PCN# 20250806001.2A
Qualification of additional Fab site (DFAB) and additional
Assembly/Test site (FMX) options for select JI devices
Change Notification / Sample Request

Date: August 08, 2025

PCN Number:	20250806001.2A	PCN Date:	August 08, 2025
Title:	Qualification of additional Fab site (DFAB) and additional Assembly/Test site (FMX) options for select JI devices		
Customer Contact:	Change Management team	Dept:	Quality Services
Proposed 1st Ship Date:	February 02, 2026	Sample requests accepted until:	October 05, 2025*
*Sample requests received after October 05, 2025 will not be supported.			
Change Type:			
☒ Assembly Site	☐ Design	☐ Wafer Bump Material	
☐ Assembly Process	☐ Data Sheet	☐ Wafer Bump Process	
☒ Assembly Materials	☐ Part number change	☒ Wafer Fab Site	
☐ Mechanical Specification	☒ Test Site	☒ Wafer Fab Materials	
☒ Packing/Shipping/Labeling	☒ Test Process	☐ Wafer Fab Process	
PCN Details			
Description of Change:			
Revision A is to correct the device group numbering in the product affected section from Group 5 to Group 6 as highlighted below. We apologize for any inconvenience this may have caused.

Sample product shipping label (not actual product label)

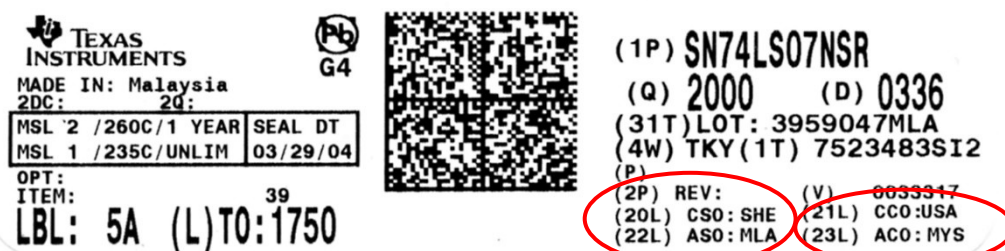
Changes to product identification resulting from this PCN:

Chip Site	Chip Site Origin Code (20L)	Chip Site Country Code (21L)	Chip Site City
SH-BIP-1	SHE	USA	Sherman
DL-LIN	DLN	USA	Dallas

Assembly Site	Assembly Site Origin (22L)	Assembly Country Code (23L)	Assembly City
TAI	TAI	TWN	Chung Ho, New Taipei City
FMX	MEX	MEX	Aguascalientes
